Re: Storm Water Inspection at Bexley Police Facility / Franklin County

This letter is written in follow-up to a construction storm water inspection by Amber Miller and Heather Nichols, of the Ohio EPA, at Bexley Police Facility located at 559 North Cassingham Road on July 6, 2009. The purpose of the inspection was to evaluate compliance with the General Storm Water Permit Associated with Construction Activities. During the inspection, we noted the following:

Figure 1: Stabilize entrance

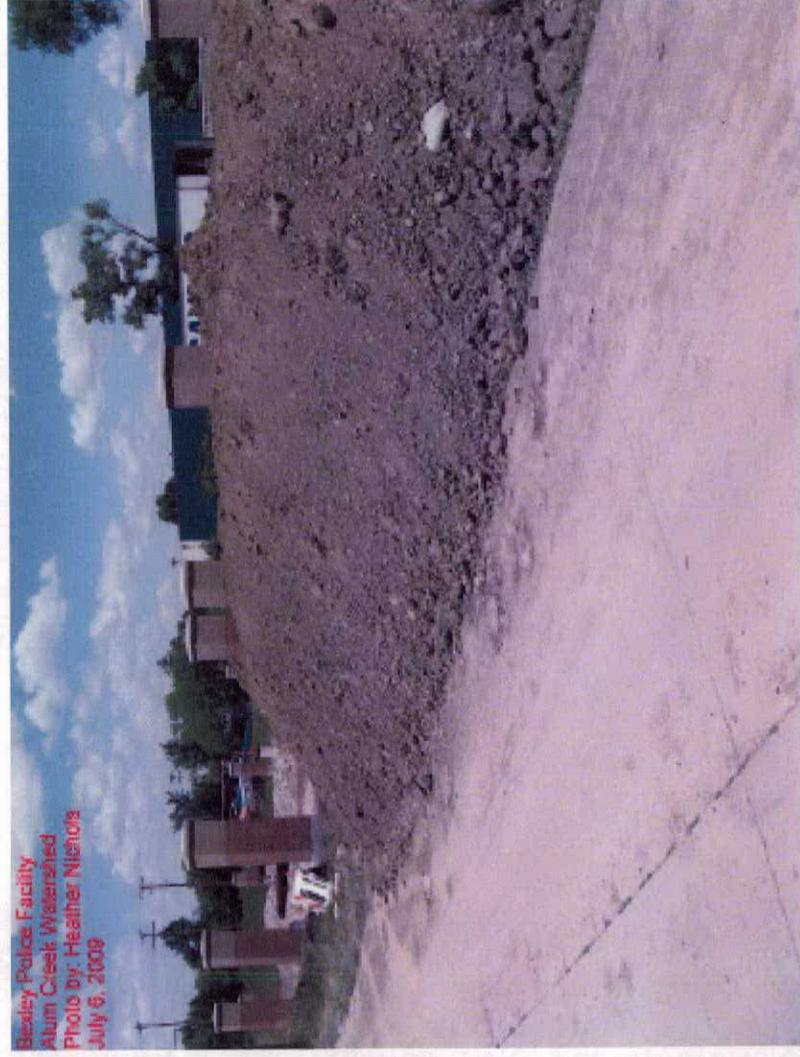
- The entrance of the site must be stabilized to minimize off site vehicle tracking (See Figure 1).
- Upon inspection it appeared that the sediment pond and perimeter silt fence were functioning as intended. Please be aware that the General Permit indicates that all sediment controls will be inspected and maintained every seven days or within 24 hours of a precipitation event equal to or greater than 0.5 inches. A log of inspection must be maintained on-site for the agency to review.
- The dirt pile indicated in Figure 2 must be protected to minimize off site sediment transport.
